## Stakeholder Comments

### SDG&E Comments on the 2020 and 2024 Local Capacity Requirement (LCR) Draft results

Submitted by	Organization	Date Submitted
<i>Effat Moussa</i>	<i>San Diego Gas &amp; Electric</i>	<i>March 28, 2019</i>

**Expected area local RA price over project life time (Nominal \$/kw-year)**

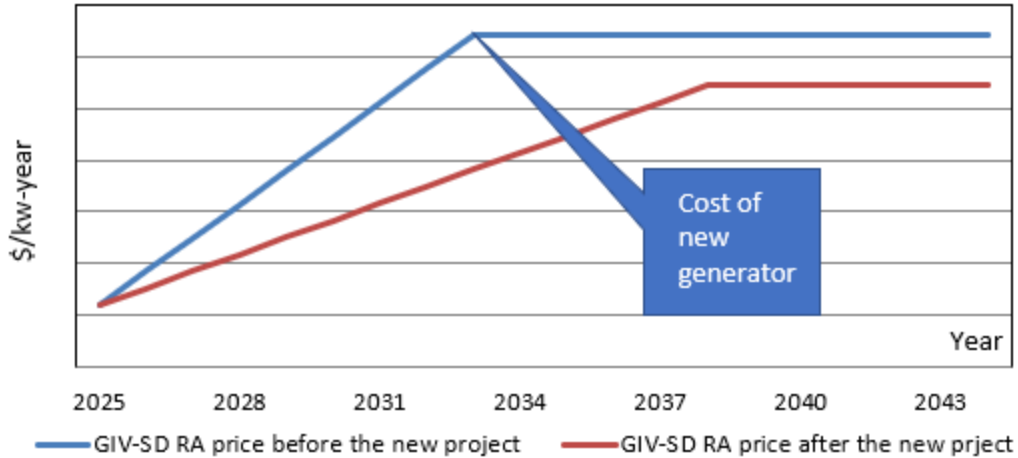
Specifically, SDG&E's proposed approach is to forecast longer term (corresponding to asset lives of 50 or more years) capacity prices by considering resource scarcities over time, the cost of building new generators that will comply with California's policies (e.g. SB100) including the replacement of such generation when their useful economic lives end, and the impact of future technology improvements on zero-carbon resources' costs (e.g. storage). The graph below illustrates such a methodology:
